NAME	EFD-4651 (14P)	MATERIAL	PM-9820	SCALE	1:1	ANGLE	45°
DRAWING NO.	HX 4602A	PIN MATERIAL	CP WIRE	UNIT	m/m	REV.	01
TOLERANCE OF PIN DIA. ±0.05		PIN TENSION LOAD 1.5 KG/MIN		UL REC.: 94V0			
TOLERANCE:							
DRAWN & CHECKED BY: LIN HUA JING		DESIGNED & APPROVED BY: LIN GUO PING		DATE: FEB 22 2011

**东莞市华欣塑胶制品有限公司**  
 DONGGUAN HUAXIN PLASTIC MANUFACTURING PRODUCTS CO., LTD.  
 TEL: 0769-86388188 FAX: 0769-86388111  
 E-Mail: hxbohhind@vip.163.com

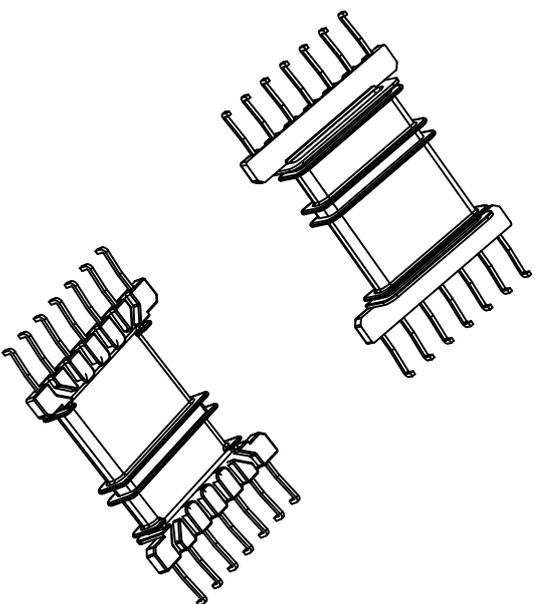
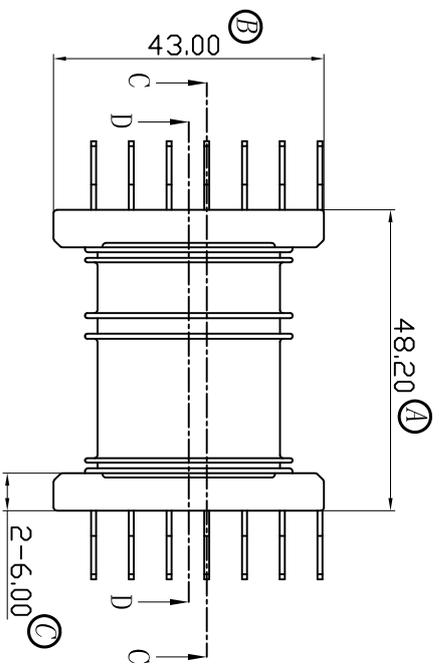
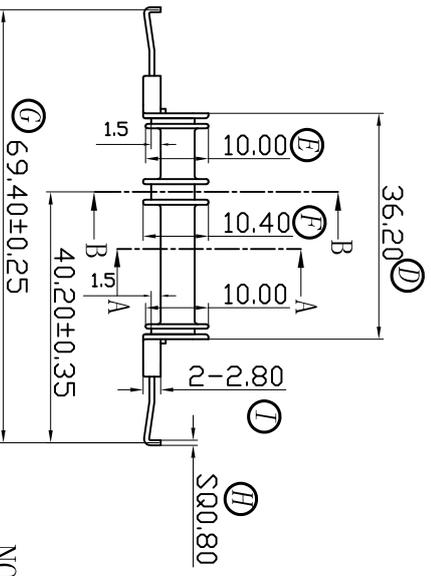
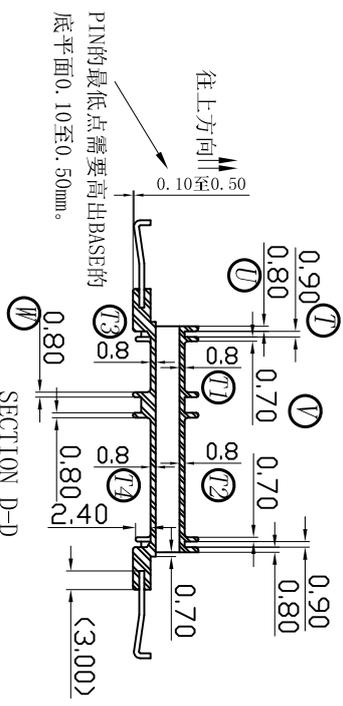
记号	日期	修改记录
1	2011/02/22	1. G, S尺寸由69.40±0.35, 2.80±0.2改为69.40±0.25, 2.65±0.2. 2. PIN的最低点需要高出BASE的底平面0.10至0.50mm。
